SAXTON NUCLEAR EXPERIMENTAL CORPORATION

DOCKET NO. 50-146
LICENSE DPB

Amendment No. 1 to Change Request No. 25

1. Applicant hereby submits Amendment No. 1 to Change Request No. 25 supplying additional information requested in Division of Reactor Licensing letter of April 12, 1967.

FIGURE VI

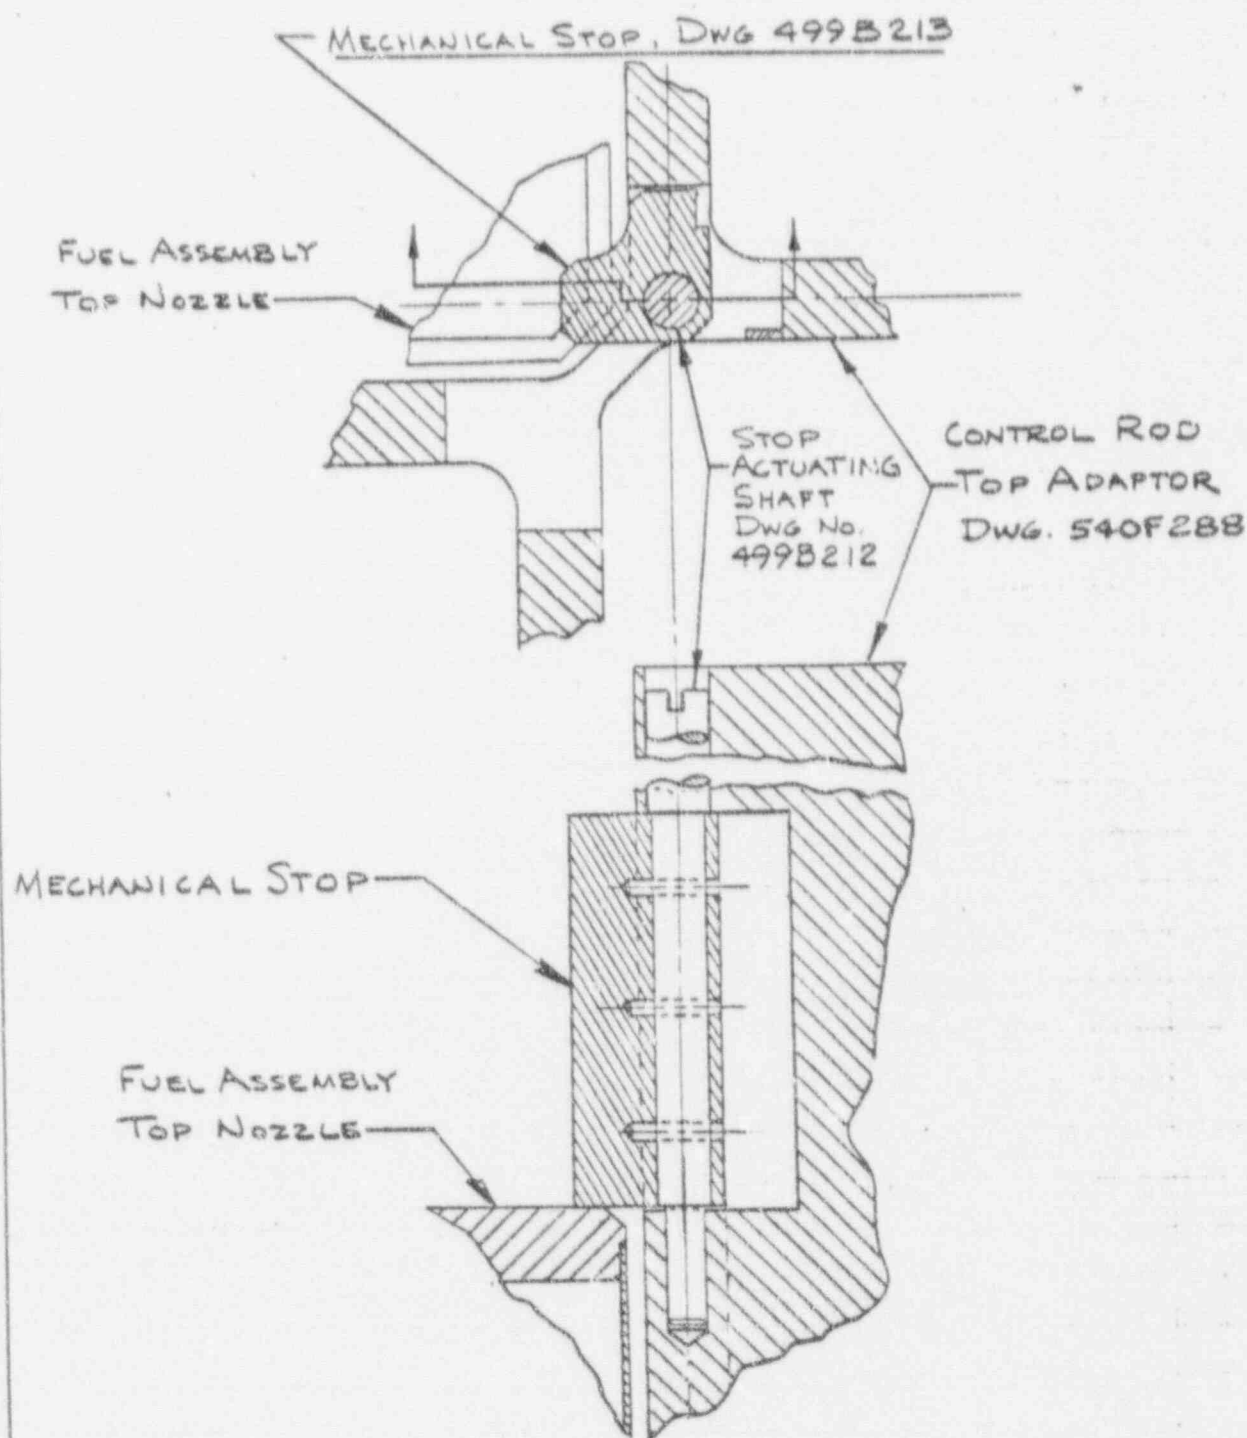
- VI. Provide a description and drawing of the mechanical stops on the control rods which are designed to prevent a rod ejection accident. Include an analysis to demonstrate that these stops would not fail in the event of a complete shearing of a control rod nozzle.

The mechanical stops (See Fig. VI) were not provided to prevent rod ejection in the event of complete shearing of a pressure vessel nozzle, but were originally designed to prevent a control rod absorber section from traveling below the active fuel region in the event of failure of the dashpot in the control rod drive mechanism during scram. Although the stops are adequate for this purpose, at the energy level of the control rod in the case of nozzle shearing it would take extensive testing and analysis to predict the results of the impact between the stop and the fuel assembly. However, even if the stop sheared completely off and did not succeed in stopping the rod, the rod would overtravel only a distance of approximately 7 inches before contacting the bottom of the pressure vessel.

Since the control rod is significantly larger in cross-section than the nozzle penetration (5.62 inch compared to 3.75 inch) the rod cannot be ejected through the nozzle. In addition, the shroud which houses the control rod in the bottom plenum comes to within 4.17 inches of the bottom of the pressure vessel and, by virtue of the clearance between the rod and shroud, would prevent the rod from deflecting sideways more than 0.32 inch.

Thus if the stop failed and permitted a control rod to continue downward, the rod would overtravel its normal position by approximately 7 inches where it would come to rest. The maximum reactivity insertion would result if the rod was initially completely in the core and was ejected downward these 7 inches. The worth of this movement is less than $0.35\% \Delta k/k$. The only time rods are completely in the core is when the reactor is shutdown, tripped, or being started up. With the reactor shutdown or tripped the

reactor is subcritical by several percent and the 7 inch ejection would have insignificant reactivity effect. Even during startup when withdrawing the last control rod (Rod #2) criticality is not normally achieved until the rod is withdrawn at least 10 inches and it is doubtful that ejecting the rod down into the core and out 7 inches would return the core to critical. Assuming, conservatively that the reactor is critical with the rod completely in, upon ejection of the rod the reactor power would tend to increase to a steady state level of 6 MWt to compensate for the 0.35% $\Delta k/k$ reactivity addition. A reactor trip signal would be initiated immediately, however, because of high startup rate and subsequently by low pressure.
